Prairie Island Nuclear Generating Plant

**Supplement to License Amendment Request dated December 11, 2000
Conversion to Improved Technical Specifications (ITS)**

By letter dated December 19, 2001, the NRC Staff sent the Nuclear Management Company (NMC) requests for additional information (RAIs) regarding our LAR dated December 11, 2000 to convert to Improved Technical Specifications. Attachment 1 to this letter contains the NRC RAIs for ITS Specification 3.3.2, "Engineered Safety Feature Actuation System (ESFAS) Instrumentation", and the NMC answers to these RAIs.

3.3.2-12 L 58 (continued)

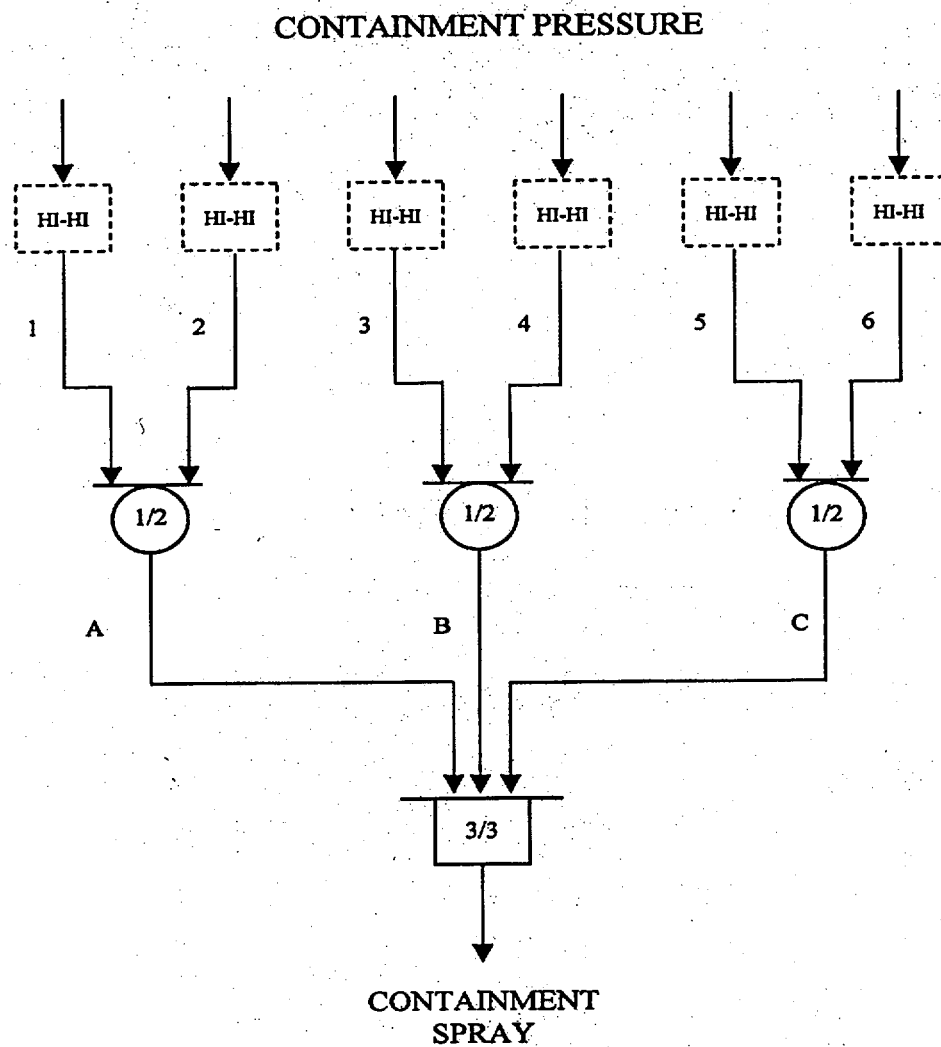
Provide a detailed discussion, include discussion of what constitutes a channel as it applies to high high containment pressure instrumentation, that justifies changing the CTS channels required to be operable.

ITS Condition E, however, represents a change to both CTS and to NUREG-1431. As proposed, required actions in Condition E permit indefinite plant operation with one channel in bypass. This less restrictive change to the PI licensing basis is not justified. Adopt NUREG-1431 Condition D or CTS for containment high pressure actuation of containment spray.

There are six high-high containment pressure sensors which are combined in three sets of two. Each pair of two sensors input to OR-Logic to provide an output. The OR-Logic inputs to a 3-out-of-3 AND-Logic to provide an output to actuate CS. Thus, if one sensor in each set indicates High-High Pressure, CS is actuated.

CTS, through Table 3.5-2B Function 2b, defines a channel as the output at A, B or C on the figure with two sensors per channel. CTS defines the total channels as three channels OPERABLE with 2 sensors per channel and the minimum channels is three channels with 1 sensor per channel. To simplify the terminology and be consistent with ISTS terminology, ITS changed the definition of channel. ITS, through Table 3.3.2-1 Function 2c, defines each sensor as a channel.

Proposed 3.3.2 Condition E will allow indefinite operation with two ITS channels (CTS sensors) inoperable with one ITS channel (CTS sensor) in bypass. This may be a less restrictive change which is the reason for L-DOC L3.3-058. CTS will allow three sensors (ITS channels), one in each pair, to be inoperable provided they are tripped. However, as noted previously, with three channels tripped, CS will actuate so this is not practical flexibility which can be used. The intent of Condition E is to retain some of the CTS flexibility by allowing two ITS channels (CTS sensors) inoperable. With one ITS channel inoperable and RA D.1 met, one ITS channel in each of the other two sets are required to actuate CS. When a second ITS channel becomes operable, the effect on CS actuation depends on whether the channel is paired with the first inoperable channel or in one of the other sets. If the second inoperable channel is paired with the first inoperable channel, then there is no further impact on CS actuation since the signal is already present from tripping the first inoperable channel in that set. If the second inoperable channel is in one of the other sets, then tripping the second channel will cause two of the three required signals for CS actuation to be present. This would leave the plant vulnerable to actuation of CS due to a spurious signal from a single ITS channel.

As a compromise, ITS 3.3.2 Condition E proposes to place the second inoperable ITS channel in bypass. If the second inoperable channel is paired with the first inoperable channel, then again there is no further impact on CS actuation since the signal is already present from tripping the first inoperable channel in that set. If the second inoperable channel is in one of the other sets, placing this second inoperable channel in bypass still leaves one channel in that set to detect high-high pressure and provide a signal. The third set is unaffected. It is NMC's position that allowing only a single High-High Containment Pressure ITS channel to be inoperable is significantly more restrictive than CTS and is not necessary with 1-out-of-2, three-times logic. The Prairie Island design for this Function differs from both of the designs on which ISTS is based and therefore, ISTS Condition D is not appropriate. CTS should not be retained because it will allow actions which will actuate CS which could create a safety consideration and the definition of channels could be confusing. Based on the discussion in DOC L3.3-058 and NSHD L3.3-058, the proposed ITS with the first inoperable ITS channel tripped and the second inoperable channel bypassed is not a significant safety hazards consideration and should be an acceptable ITS for Prairie Island. No changes have been made to the ITS submittal in response to this RAI.
